# Certificate of Appropriateness 5 E Wilson Street

October 18, 2021

## Proposed Work

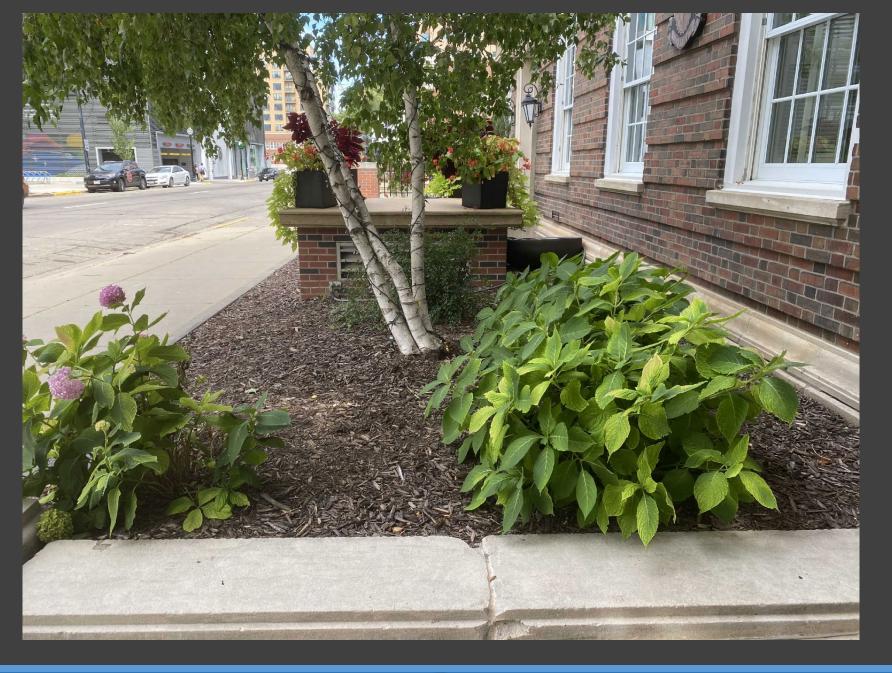
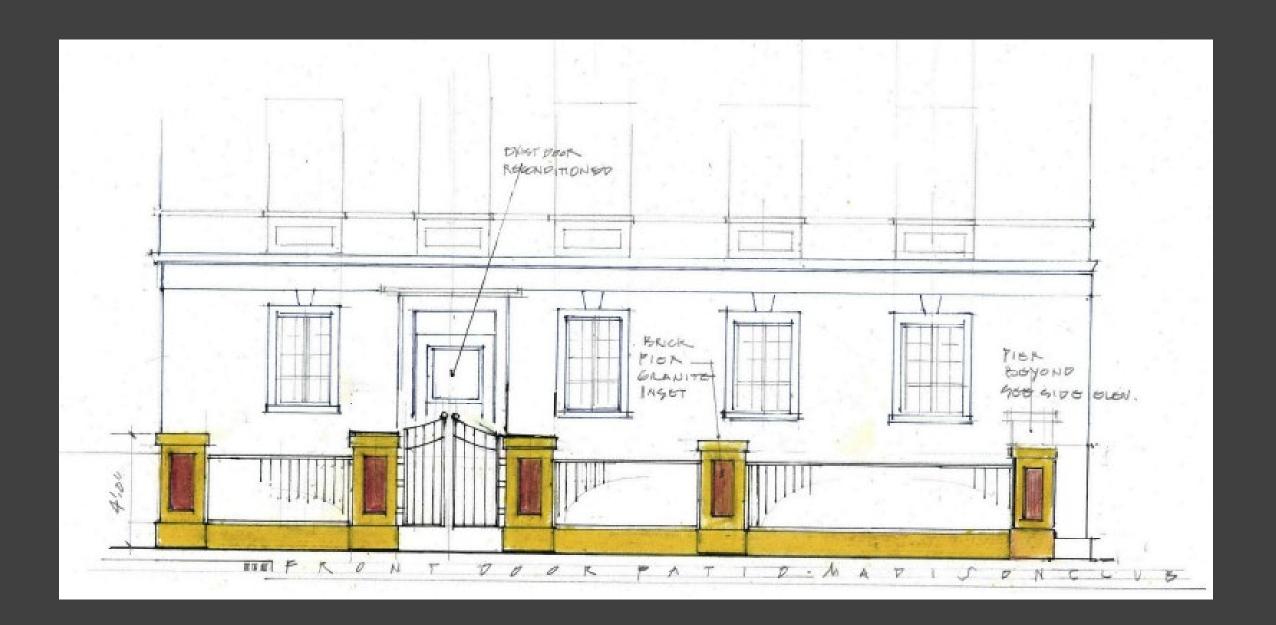
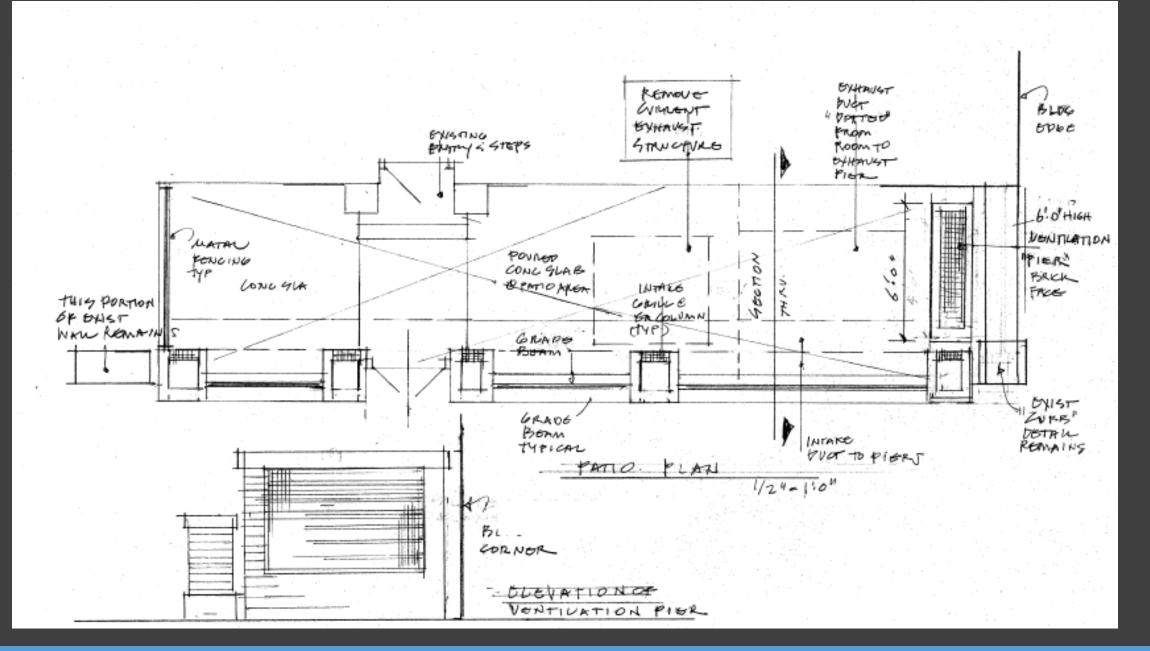
- Removal of existing planters and air intake structure
- Construction of concrete patio with fencing and gate
  - Air intake incorporated into fence

Staff believes the standards for granting a Certificate of Appropriateness could be met and recommends that the Landmarks Commission approve the project with the following conditions:

1. Masonry specifications be approved by staff
